PROJECT BRIEF

Historic District Board of Review Application for Certificate of Appropriateness at 1205 W Main St. to add front porch. Remove existing windows on the east side and replace them with smaller windows. Replace front door. Extend rear deck. Remove rear windows. Move back door 1-ft east.

HDBR Meeting Date: November 27, 2023

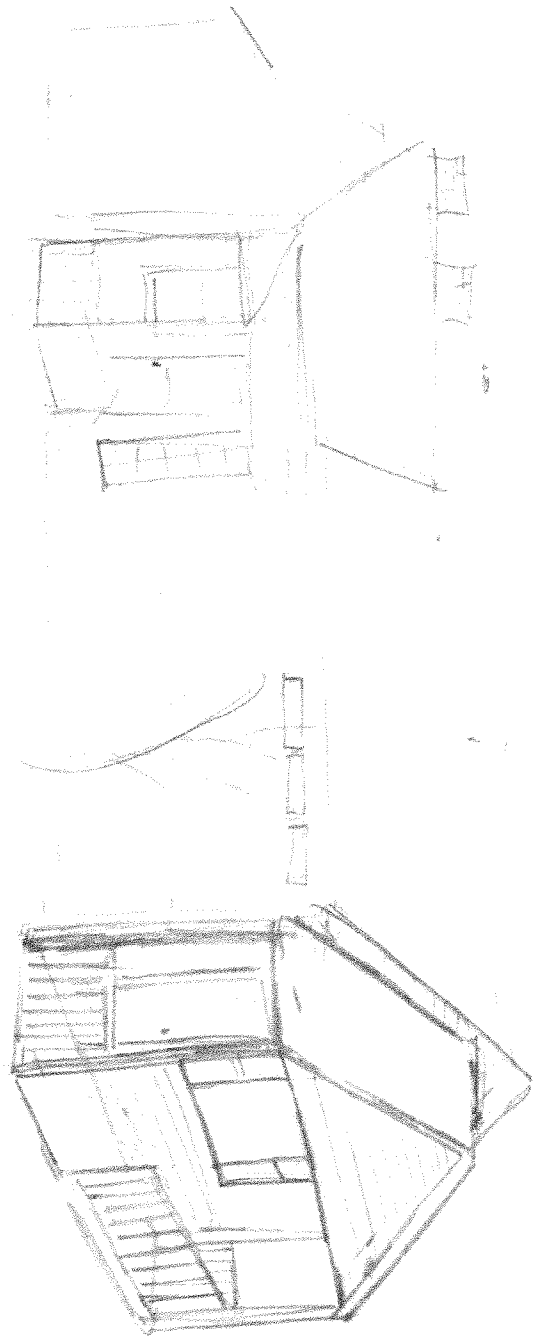
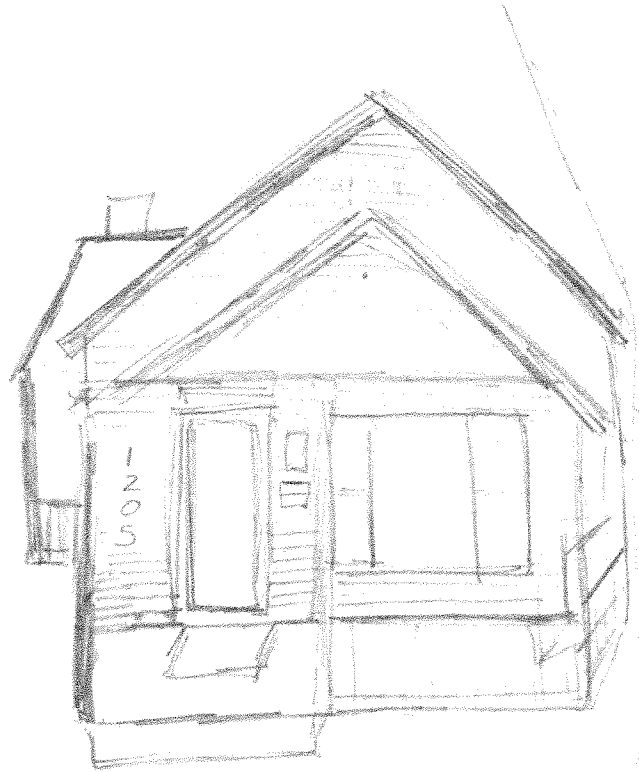
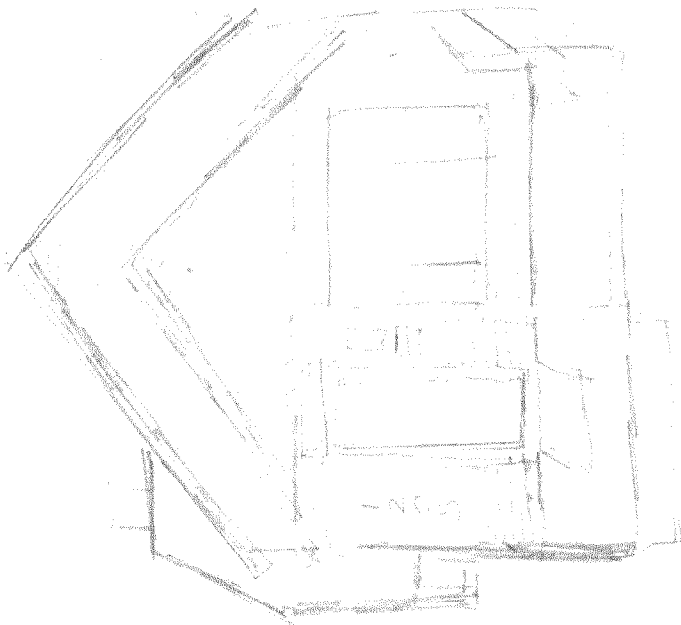
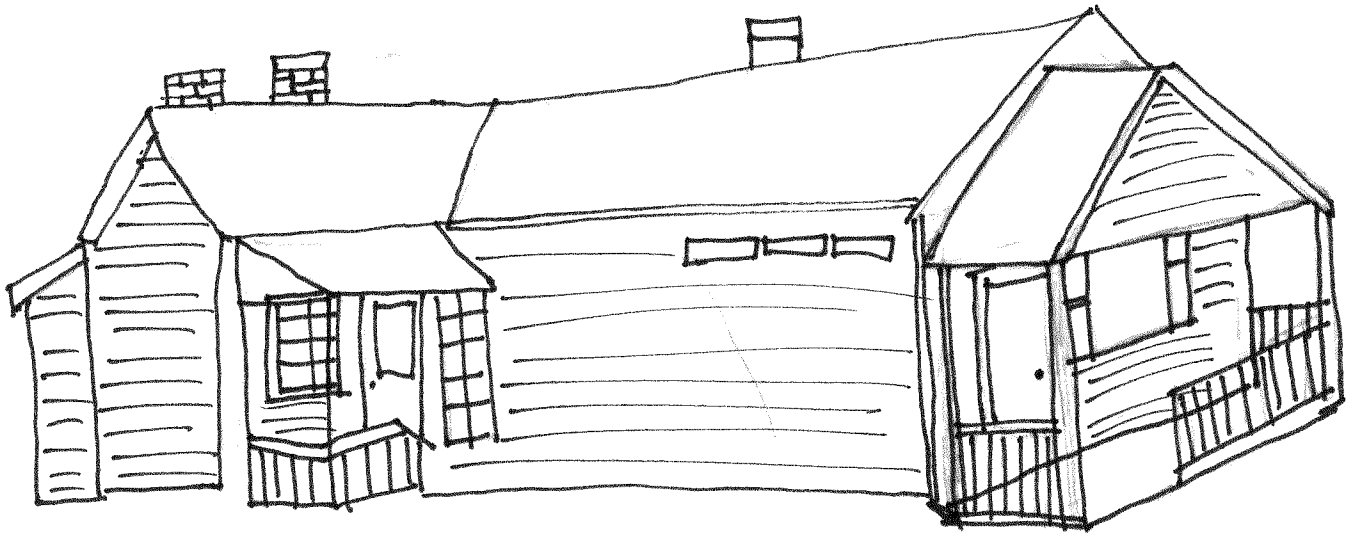
Propose porch similar to nearby house except with roof line parallel to existing structure

Propose removal of east side window (not original to the house) and add small windows above to allow lighting (see sketches)
